ADDENDUM 1 TO REPORT ON

SOIL BACKFILL CONDITIONS

SAN ONOFRE NUCLEAR GENERATING STATION

JULY 12, 1983

Fig.
 1

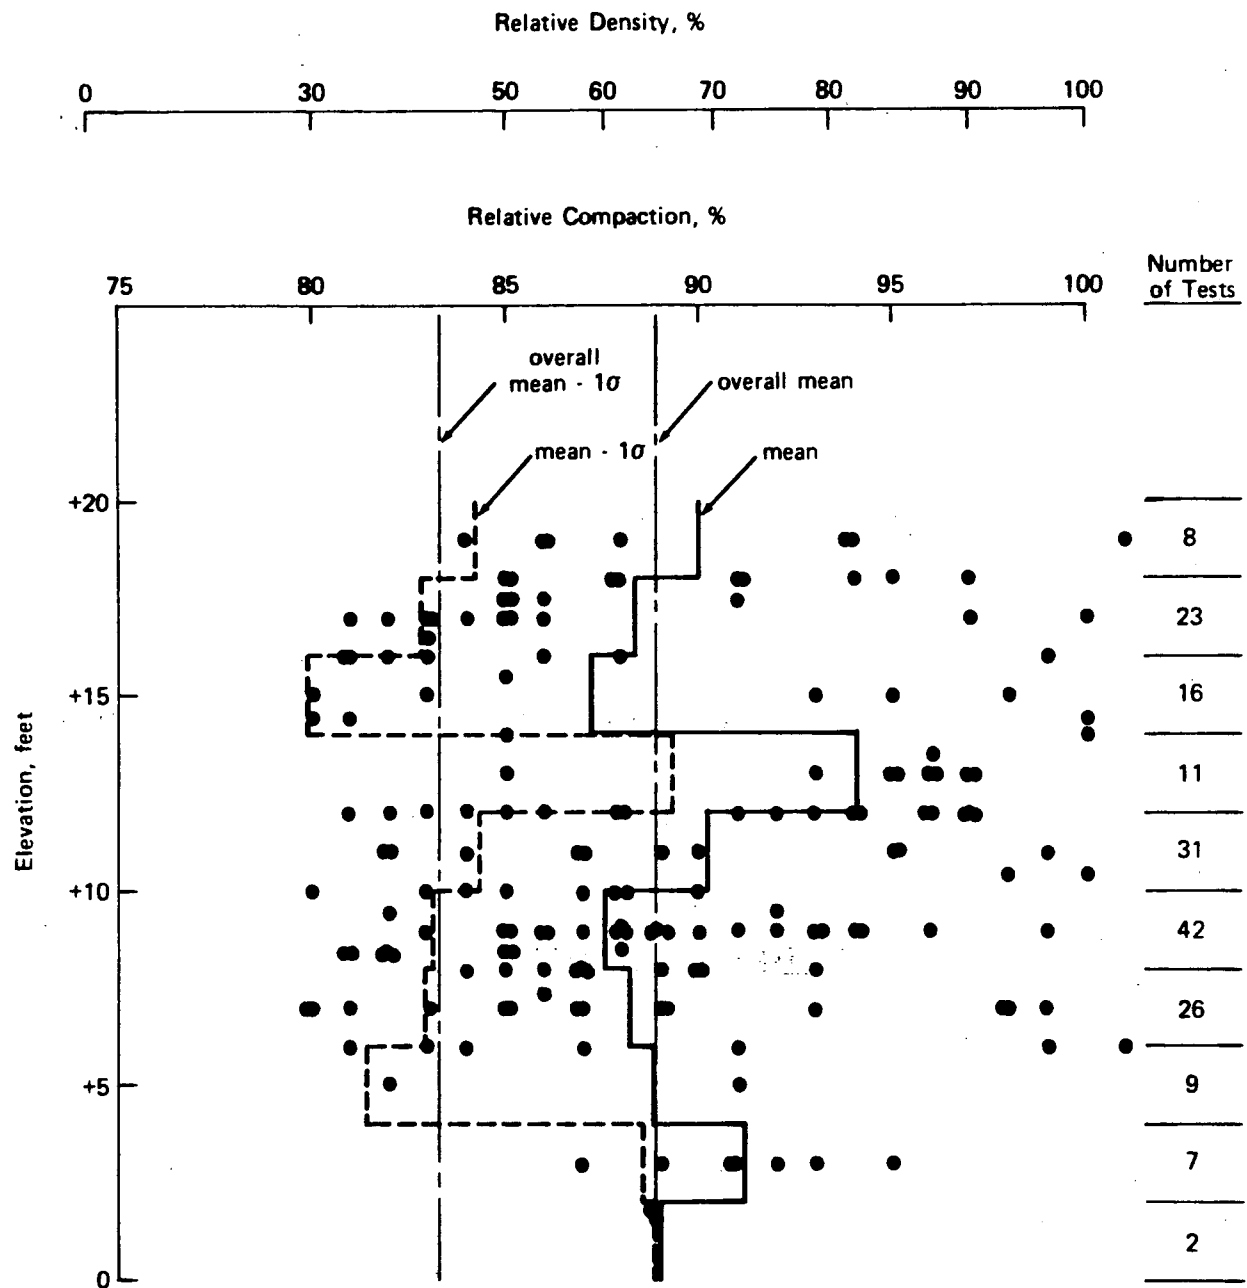
As shown by Figure 1, the overall mean and mean minus one standard deviation are about 89 and 83 to 84 percent relative compaction, respectively. The corresponding two-foot interval results and the distribution of data points show no specific trend with elevation. Further, as shown in Figure 1, 85 percent relative compaction corresponds to 50 percent relative density while 80 percent relative compaction corresponds to 30 percent relative density. It is considered unlikely that a soil deposit could remain at 30 percent relative density areally in a location such as the SONGS site where vibrations due to the operation of the power plant equipment or construction equipment have been almost continuous for over 15 years. Based on the aforementioned observation, the results of the 11 tests obtained at the east end of the Fuel Storage Building and on the lack in trend of density with elevation shown in Figure 1, it is concluded that 85 percent relative compaction is the appropriate value for use in settlement calculations.
